Quad Cities Nuclear Power Station, Units 1 and 2
Facility Operating License Nos. DPR-29 and DPR-30
NRC Docket Nos. 50-254 and 50-265

Subject: NRC Request for Additional Information

ATTACHMENT
Response to Request for Additional Information

Fire Protection Engineering Evaluation
Q-ECDS-00-165

FIGURE E-2

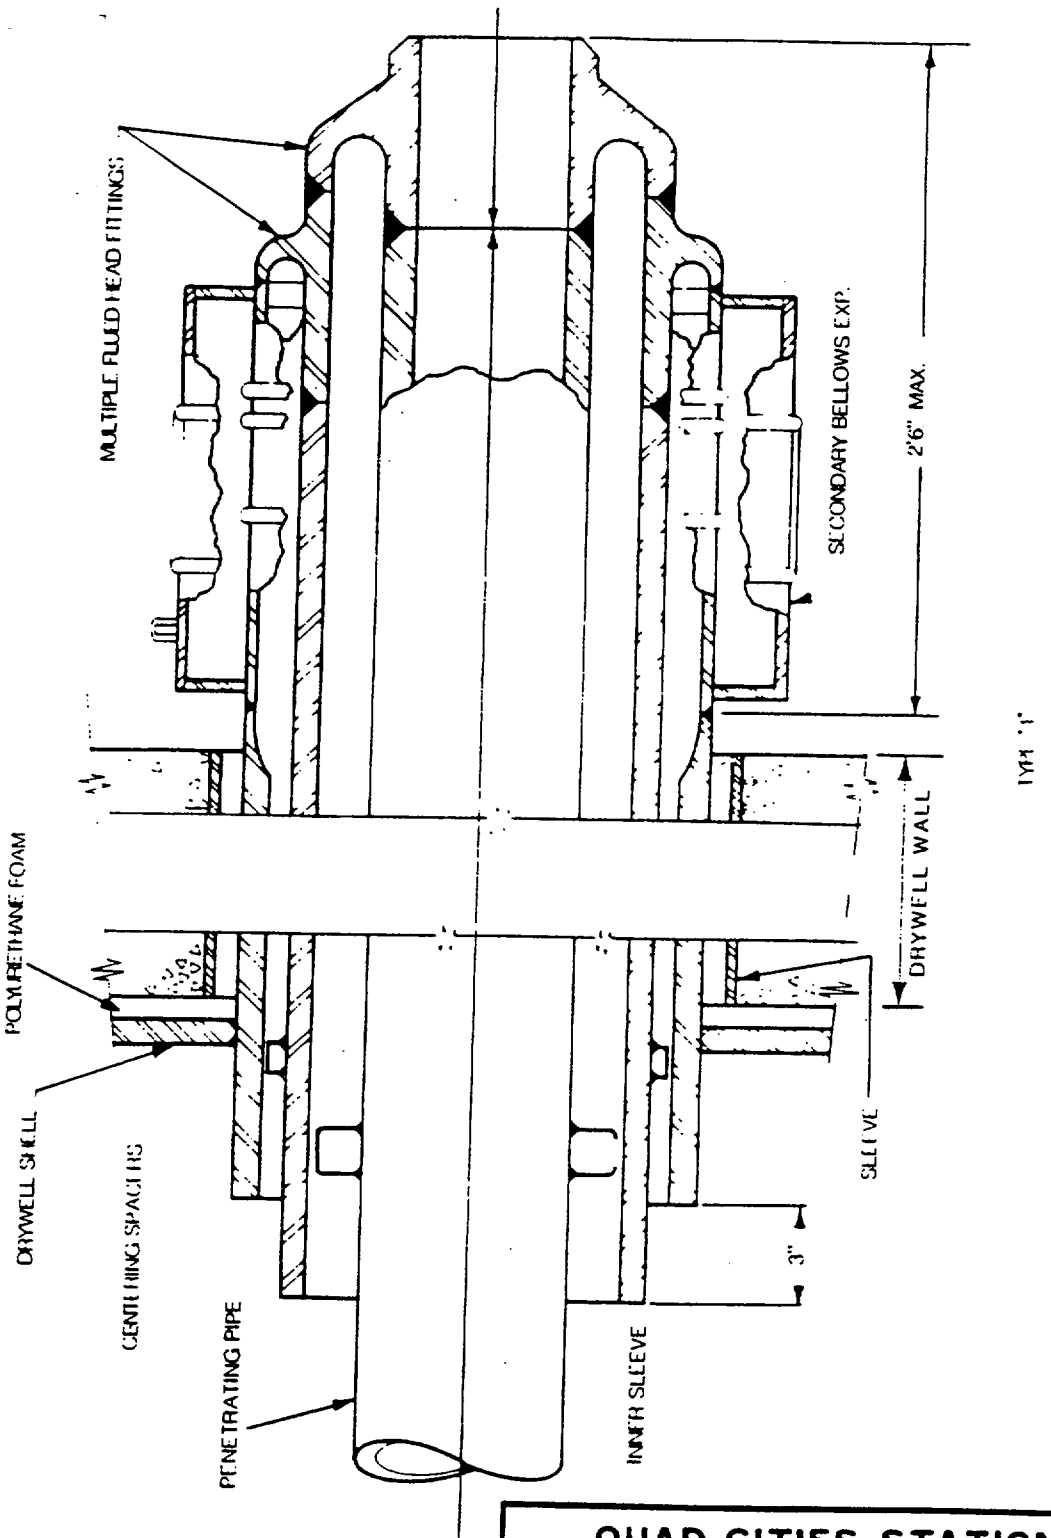
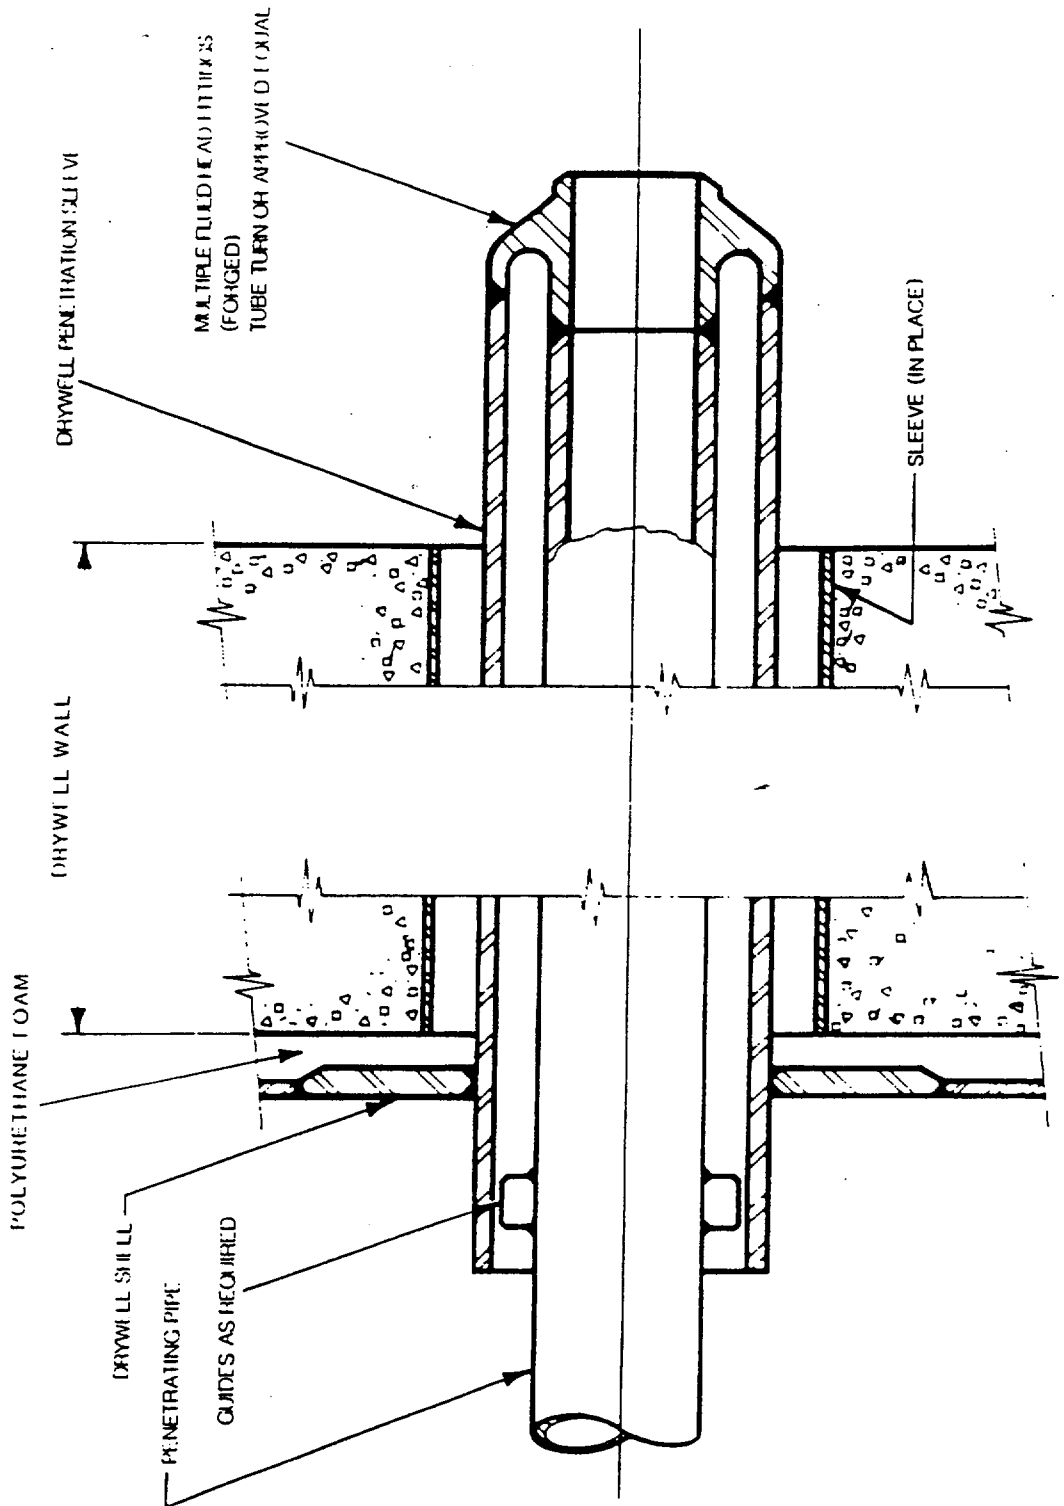
4. *In the letter dated November 1, 2000, each exemption withdrawal request provides an explanation of why a fire in the expansion gap would not spread to outside the expansion gap, but no basis is provided to show that a fire confined within the expansion gap would not adversely affect redundant safe shutdown equipment which penetrates the expansion gap. Provide a technical justification for concluding that a fire confined within the expansion gap would not adversely affect redundant safe shutdown components routed through the expansion gap.*

6. *In the letter dated November 1, 2000, it is stated in each exemption withdrawal request that a technical evaluation has been completed which demonstrates that the protection features provide an adequate level of protection, but the application does not provide the basis for this evaluation. Provide a basis and technical justification that the protection features are adequate to protect against the hazards in the area.* (Note: The November 1, 2000 letter only requested withdrawal of the expansion gap exemptions for Unit 1 and Unit 2).

The location of the expansion gap and foam sheeting with respect to the penetrations is shown on attached Figures E-1 and E-2, sheets 1 and 2. Theses are the basic configurations for each of the mechanical and electrical containment penetrations. Based on these configurations, it is apparent that the foam sheeting material within the expansion gap is completely isolated from the penetration opening and from the penetrating objects. The separation is provided by steel sleeves and plating. Therefore, there is no direct contact or fire exposure to or from the foam sheeting. Furthermore, welded-end steel fittings, sleeves, or headerplates provide a complete airtight containment enclosure around the penetration openings.

During plant operation, there are no direct paths for fire, heat, smoke or flames to traverse a penetration or impinge directly upon the foam sheeting. Additionally, there are no sources of ignition inside or adjacent to the expansion gap. The foam sheeting does not present itself as an intervening combustible since there is no equipment that directly penetrates into the expansion gap area. All penetrating objects go through a steel sleeve which is physically separated from the expansion gap and its associated foam sheeting.
